Responses to all the Comments in Petitioner's Application

7. The property at 145 E. Algonquin Road is zoned M-2, Limited Heavy Manufacturing District. A Land Use Variation for an 'Adult Day Care Center' in the M-2 district is required. The Chinese language lab is considered a commercial school and is a permitted use in the M-2 district. The In-home care service office is classified as a Business/Professional Office and is a permitted use within the M-2 district.

Attachment I

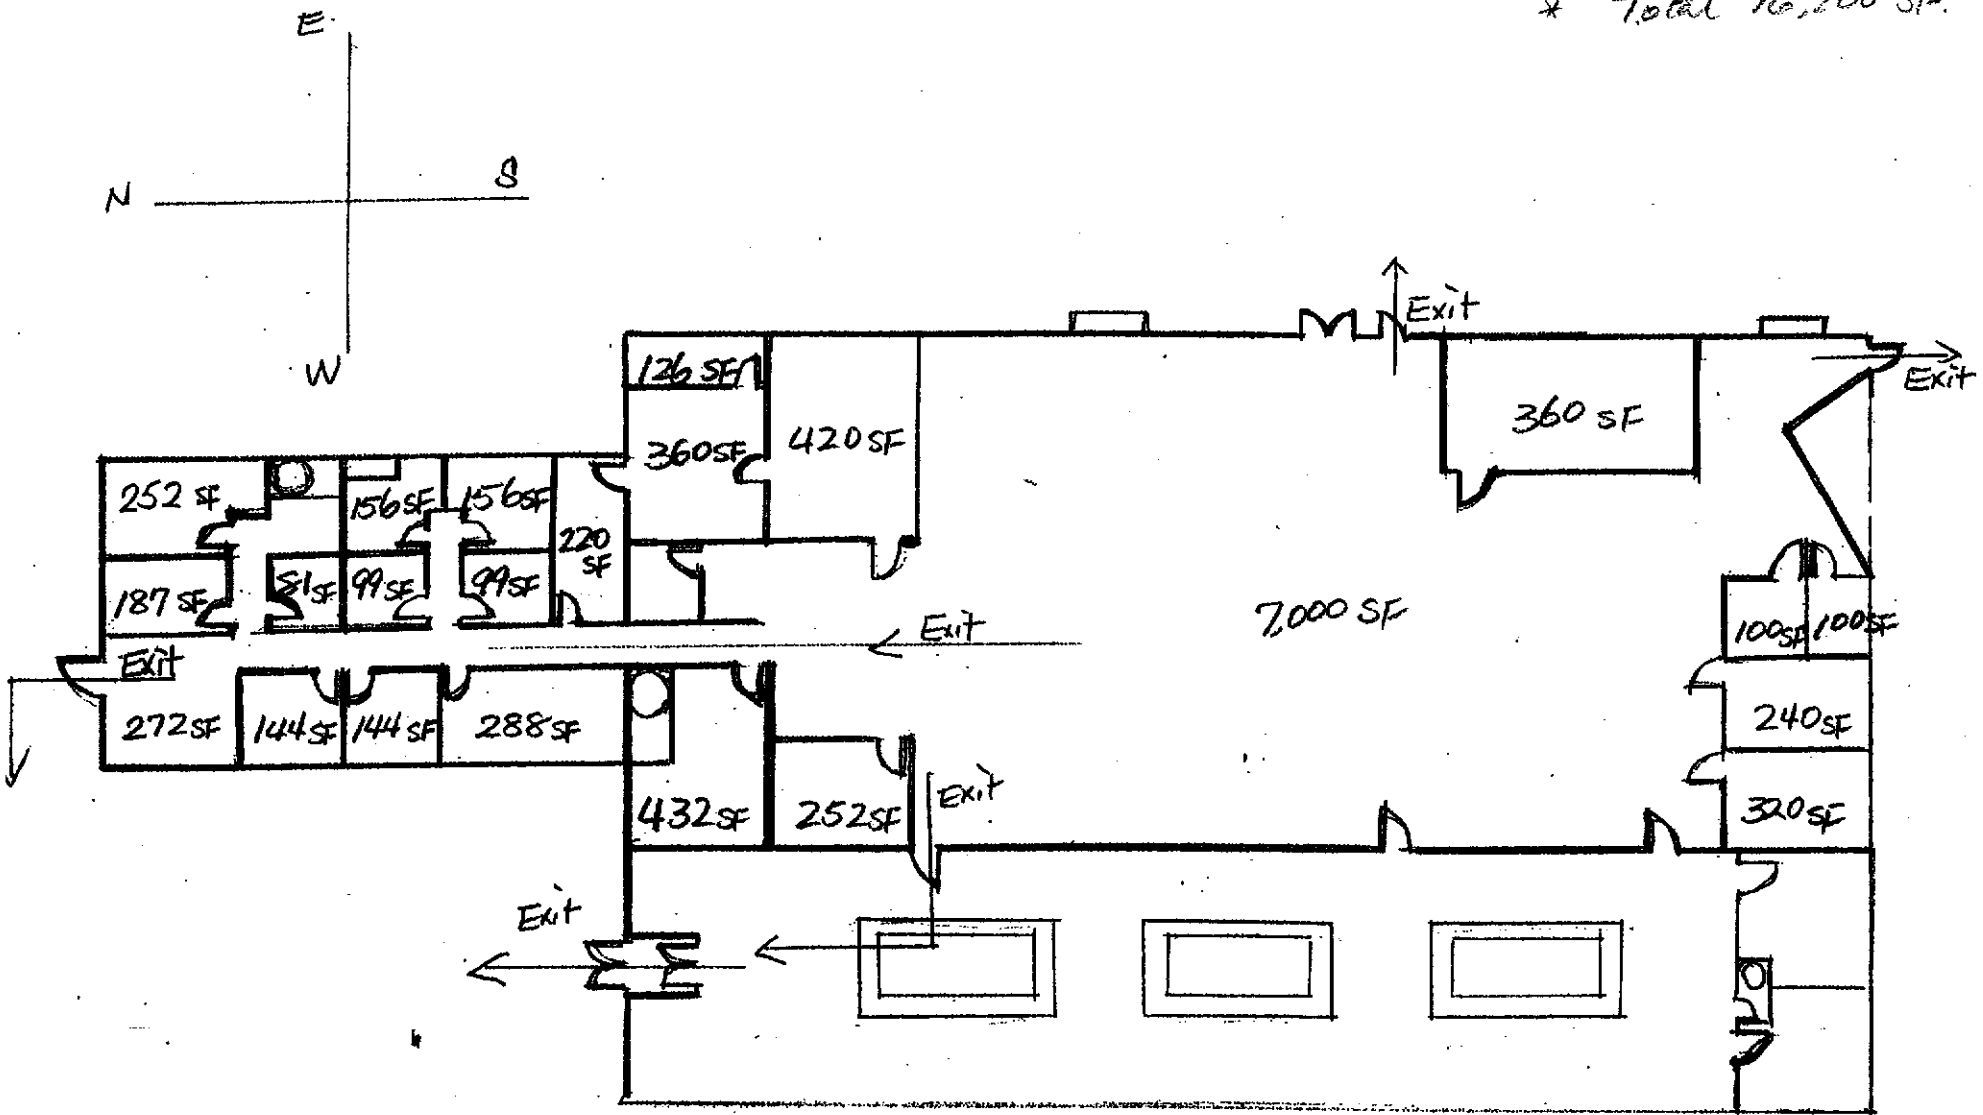
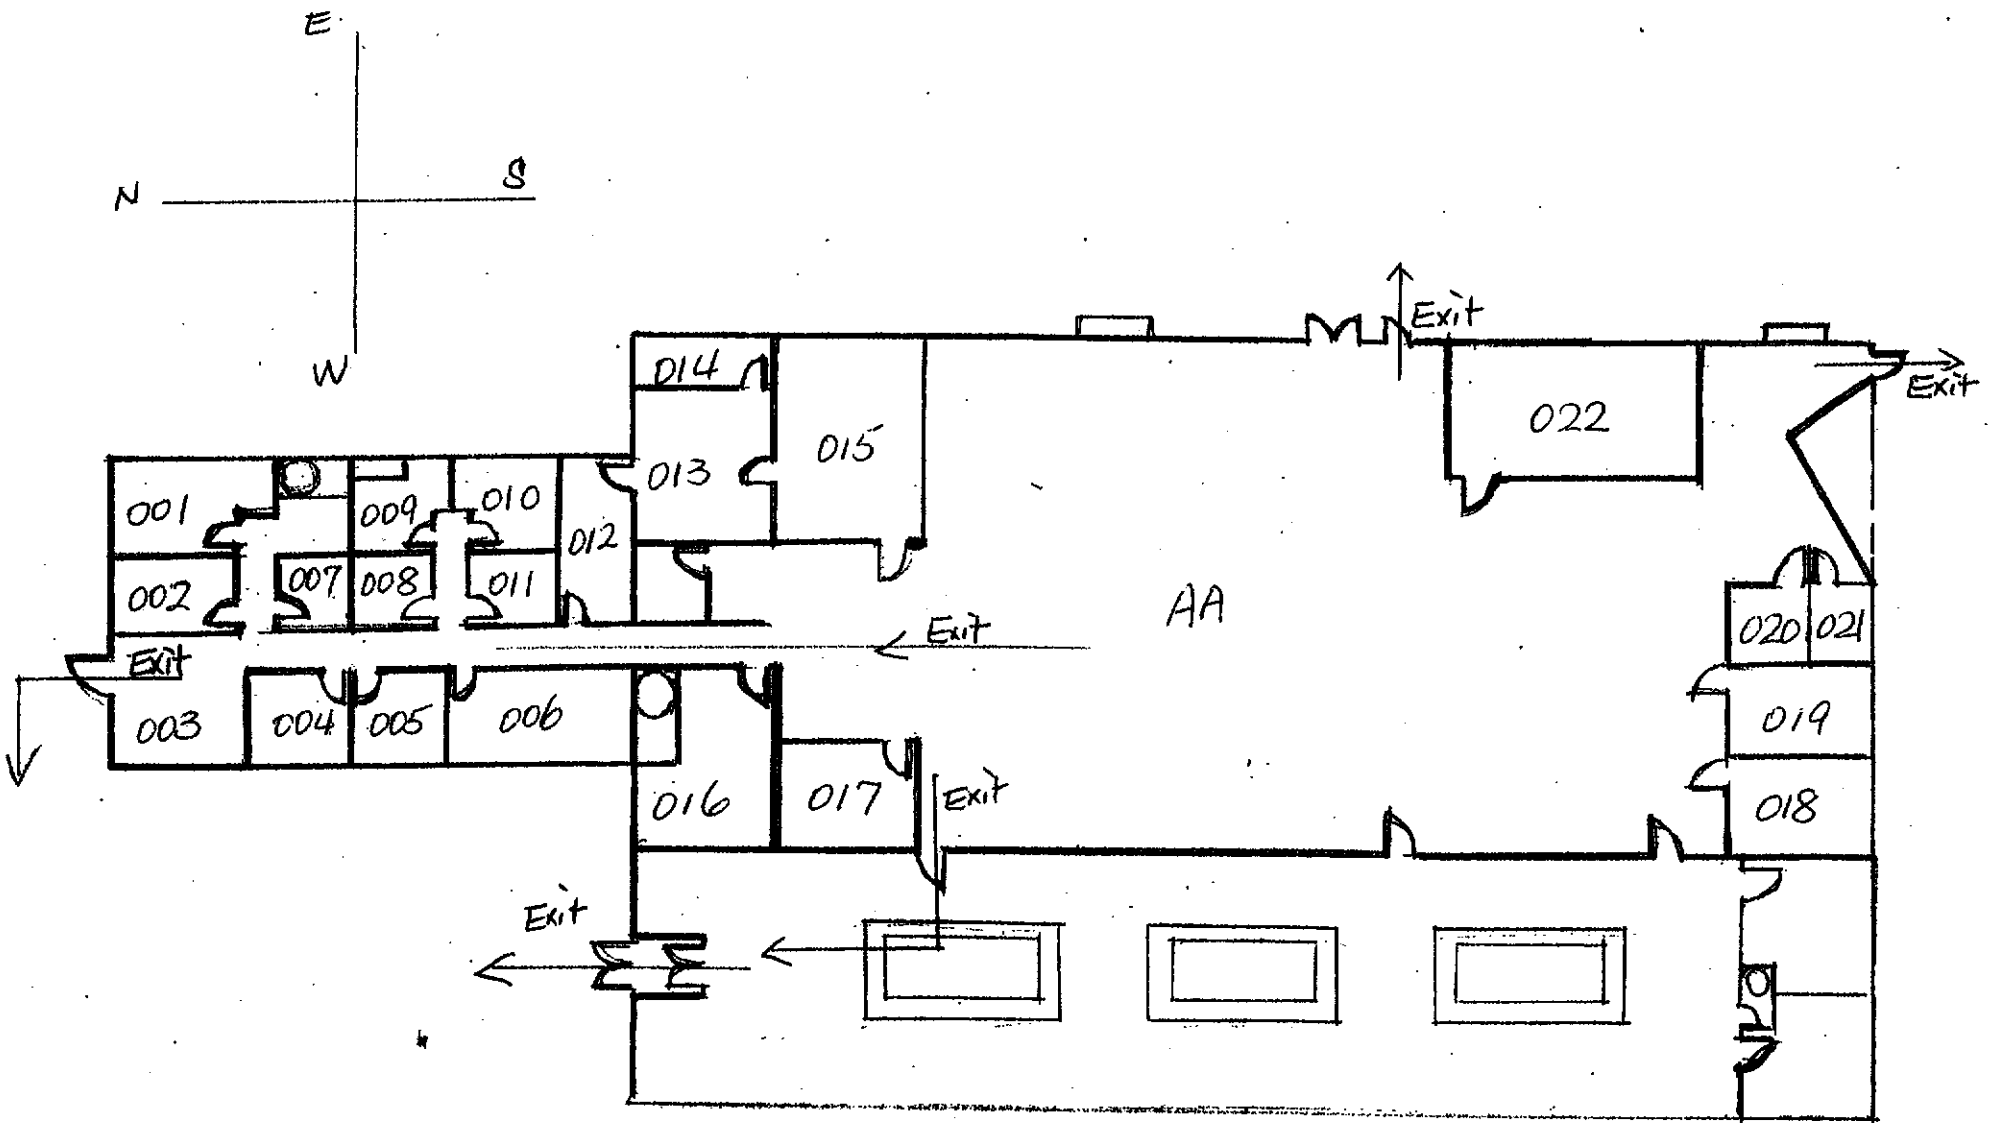
3. Indicate location and number of exits.

16. The floor plan is not dimensioned. Please provide a dimensioned plan.

Answer: Please see attached diagram I. (Room number with function and square foot, as well as the fire exit for future area)

Answer: Please see attached sheet I. (Room number with function and square foot, as well as the fire exit for future area)

Attachment II

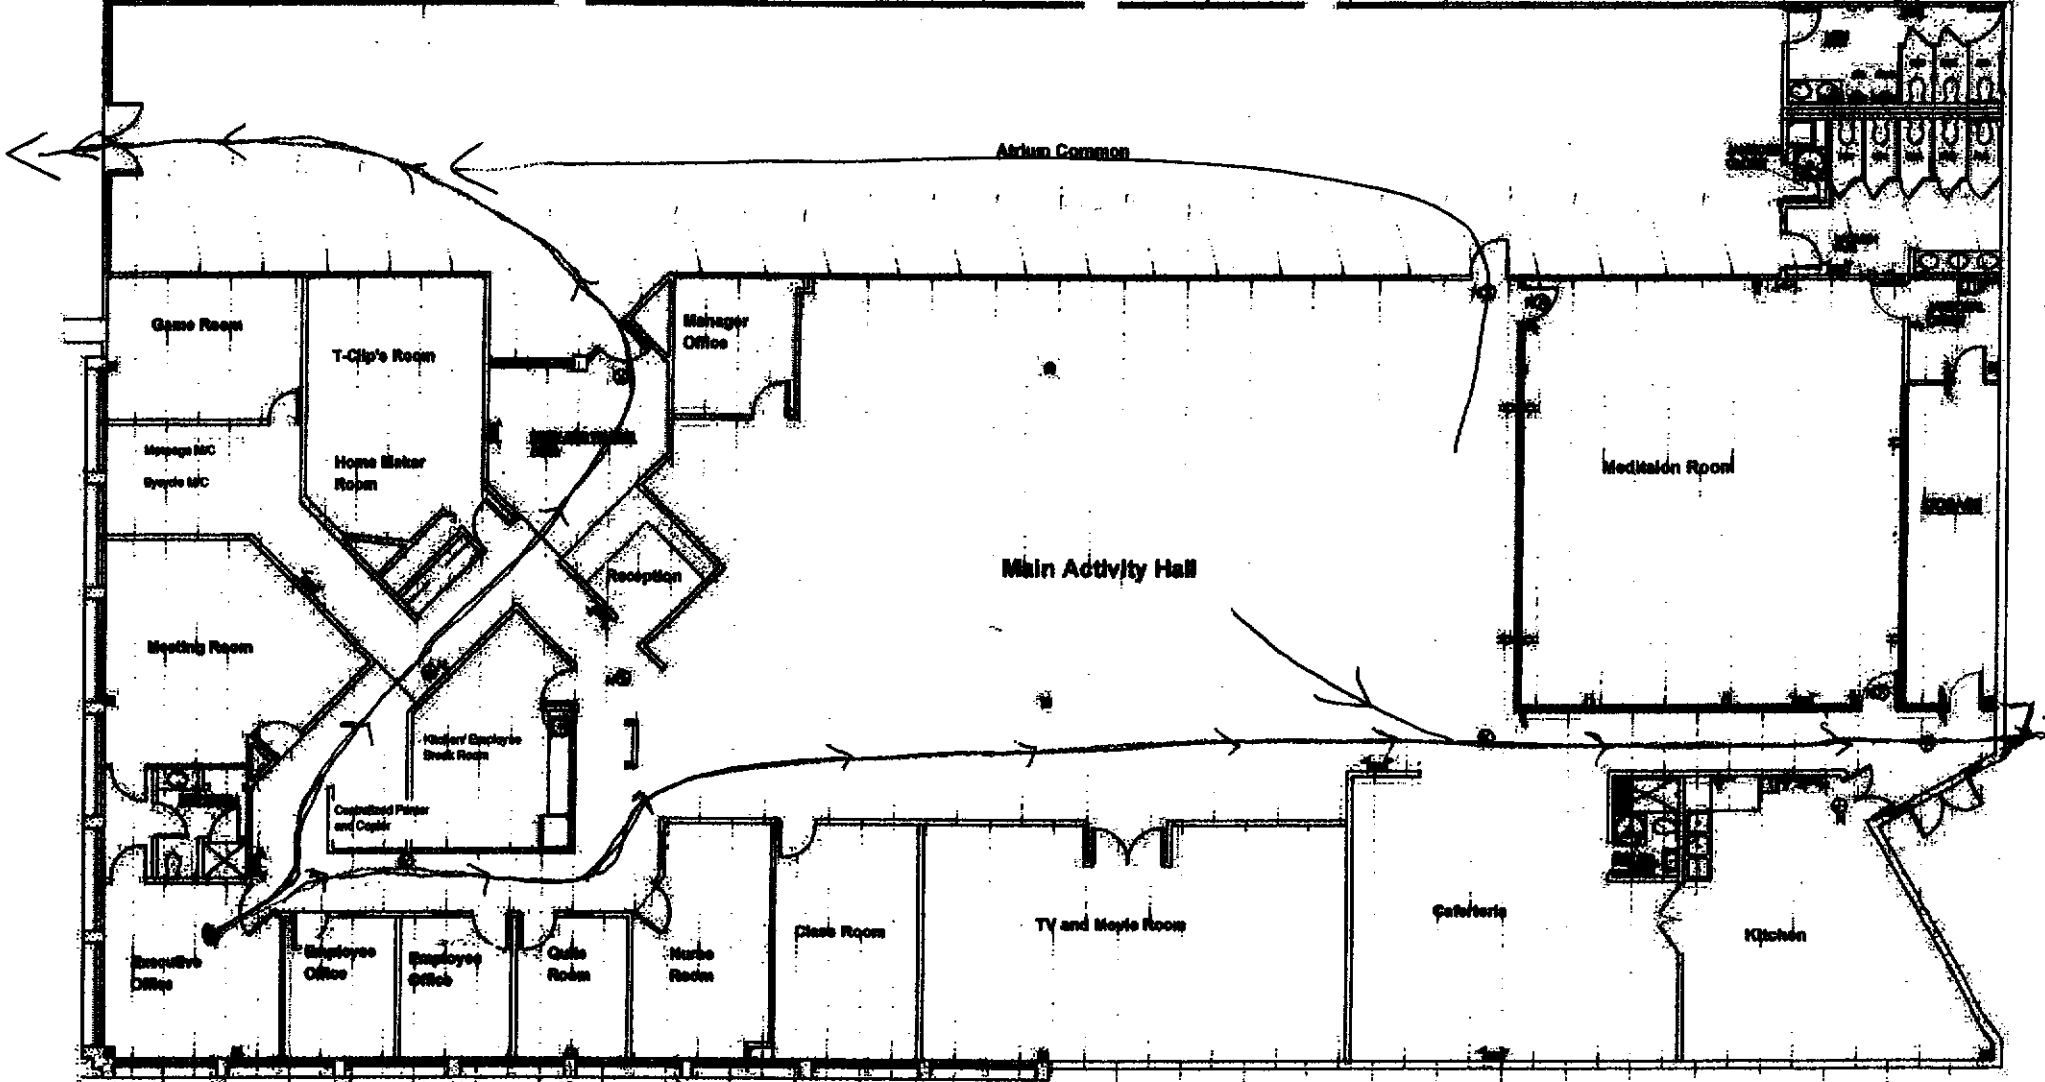
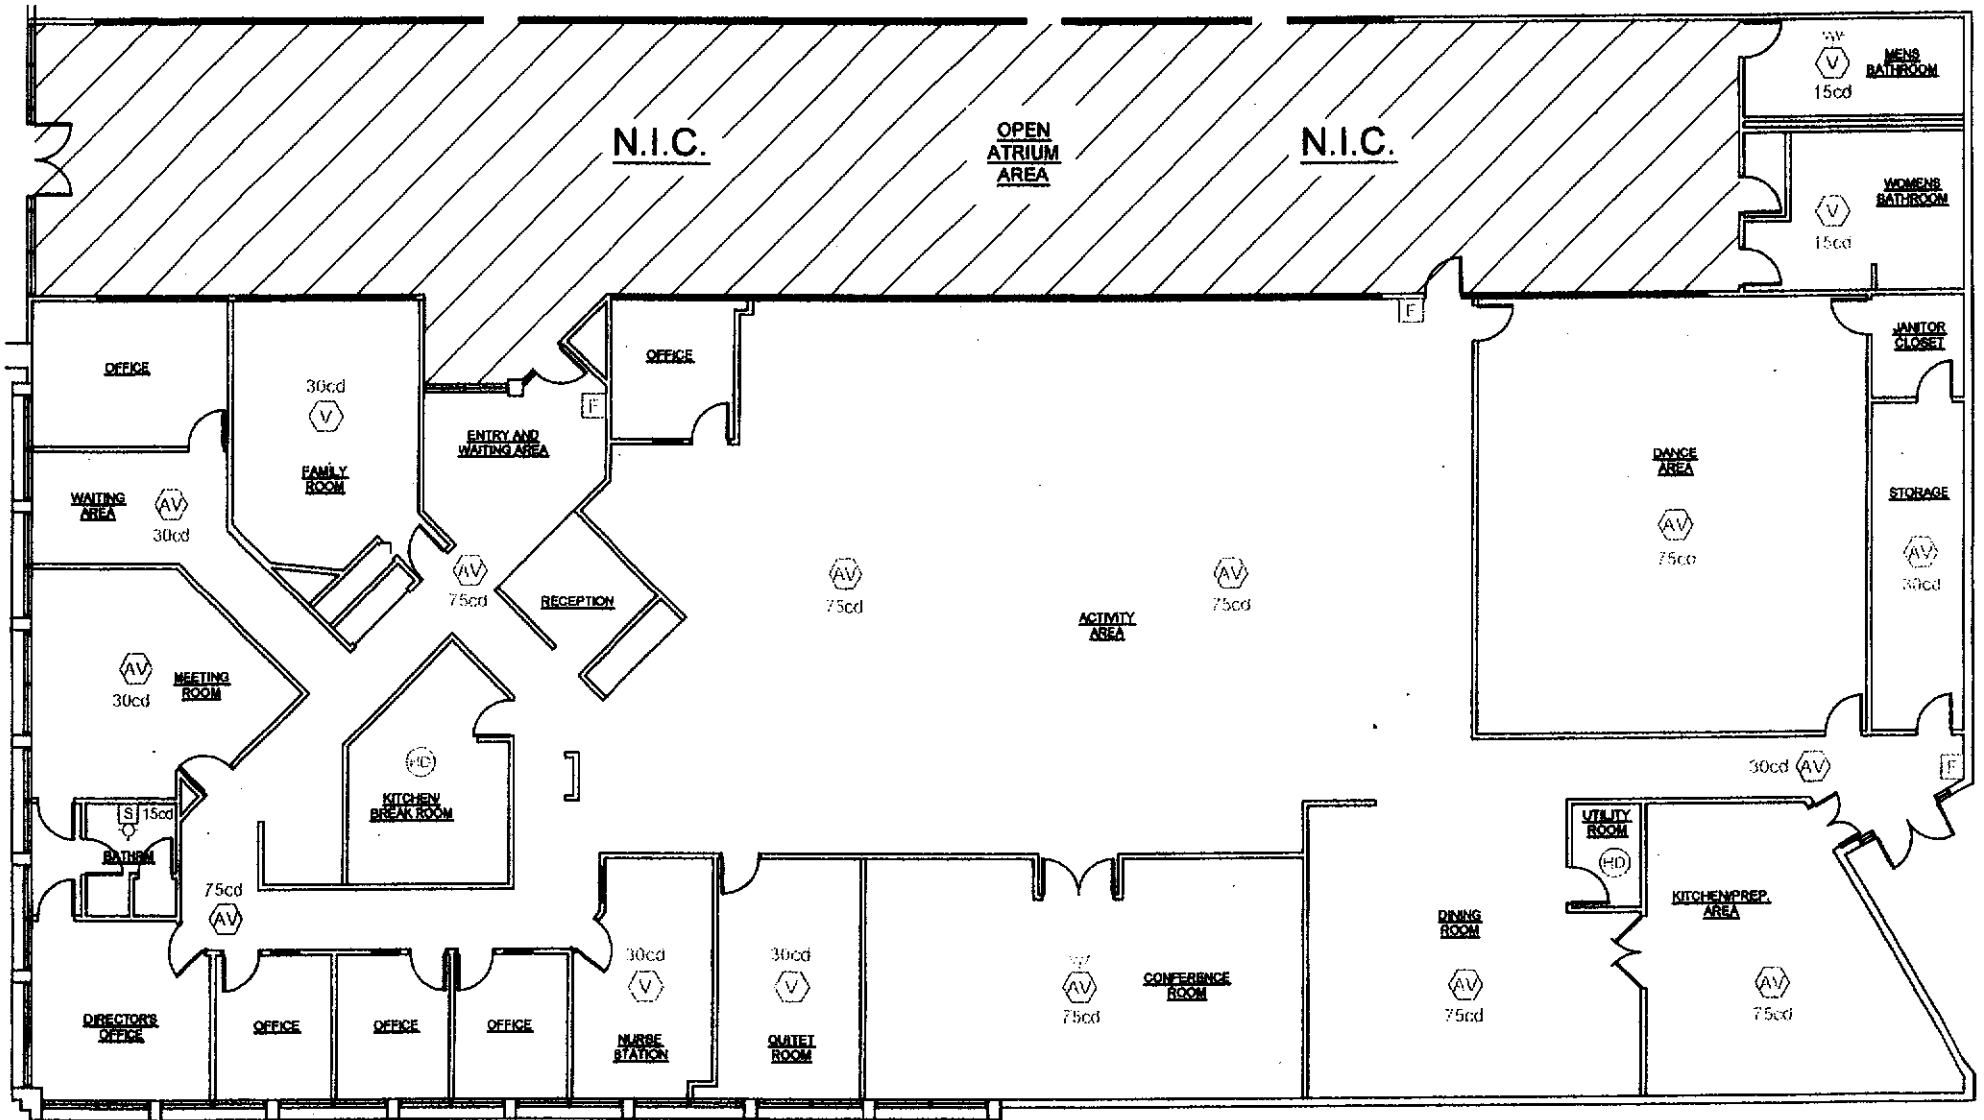
From Fire Safety Plan Reviewer: 1. Plans are too incomplete to conduct a review. Show the existing facility and how the expansion will be incorporated.

Answer: Please see attached diagram II. (The fire exit for existing area)
